STAFF REPORT
COMMUNITY DEVELOPMENT DEPARTMENT

HEARING DATE: 4/12/2022
TO: Mayor & City Council
FROM: Sonya Allen, Associate Planner
208-884-5533
SUBJECT: FP-2022-0010
Woodcrest Townhomes – FP, ALT
LOCATION: 1789 N. Hickory Way, in the SE ¼ of
Section 5, Township 3N., Range 1E.

Final plat consisting of 19 building lots and 5 common lots on 1.97 acres of land in the R-15 zoning district for Woodcrest Townhome Subdivision.

B. Final Plat (date: 2/7/2022)

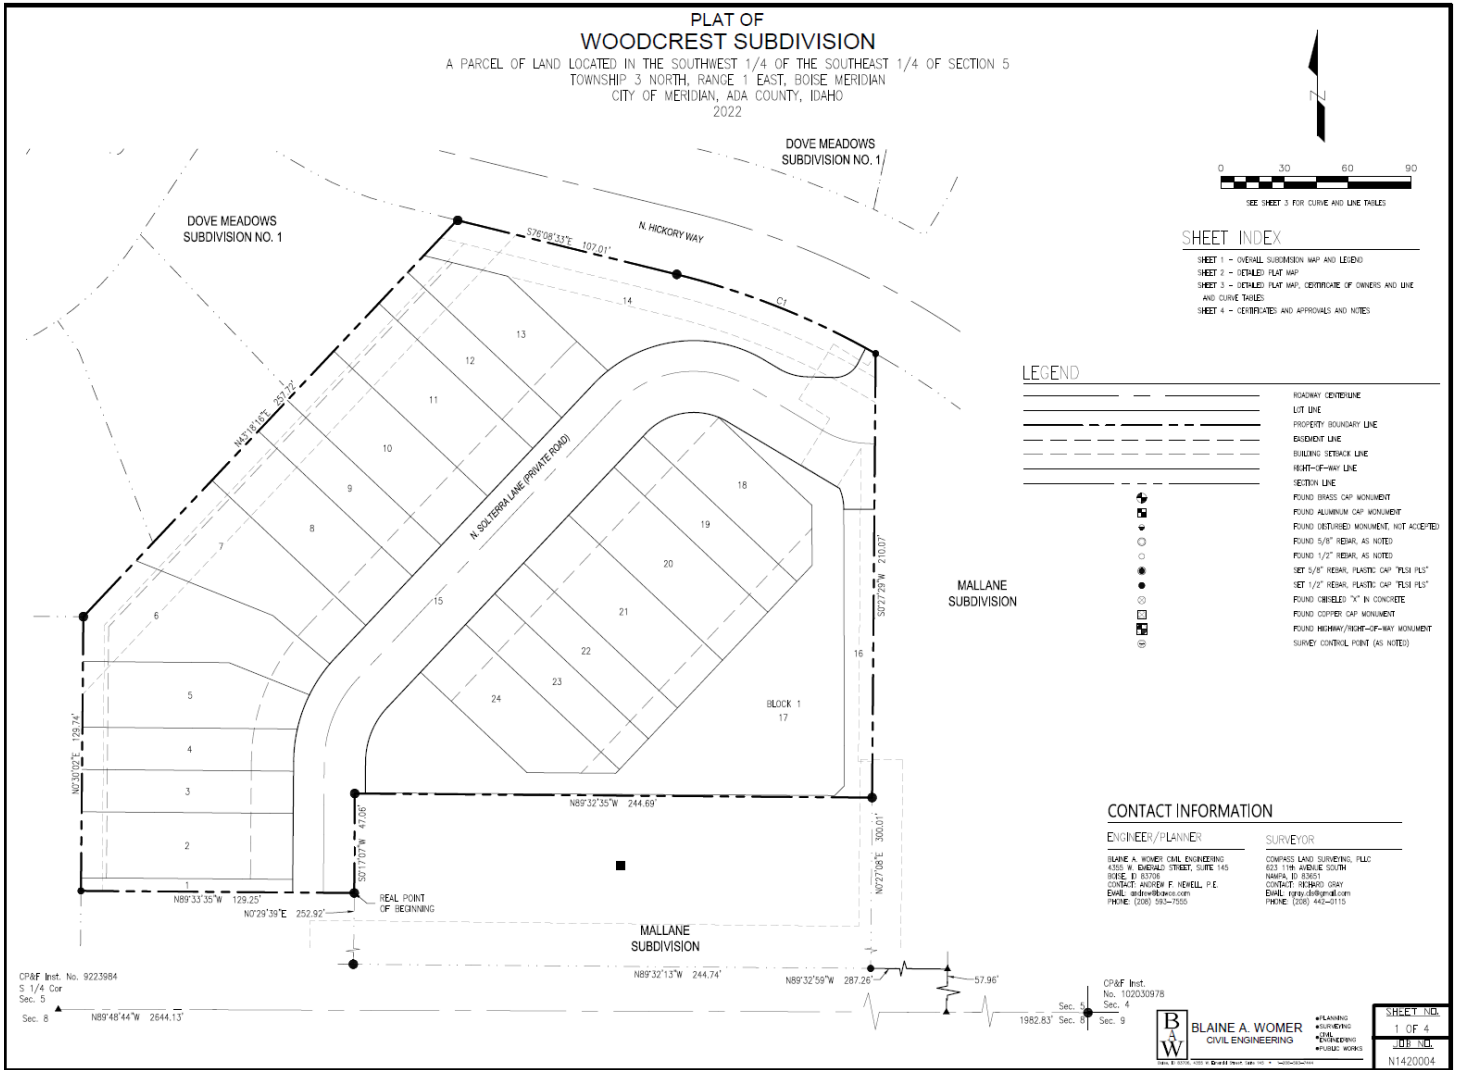
3. Prior to submittal for the City Engineer's signature, have the Certificate of Owners and the accompanying acknowledgement signed and notarized.
4. The final plat shown in Section V.B prepared by Blaine A. Womer Civil Engineering, shall be revised as follows:

- a. Note #10: "Lots shall not be reduced in size without prior approval from the health authority and the City of Meridian."
 - b. Note #14: Include the recorded instrument number of the ACHD landscape license agreement.

- c. Note #15: Include the recorded instrument number of the NMID license agreement.
 - d. Remove the former 25' landscape easement along the project's northwest boundary as it's no longer required with residential development.

- e. Remove the building setback line from the face of the plat and the Legend.
 - f. The final plat shall be stamped, signed and dated by the PLS.
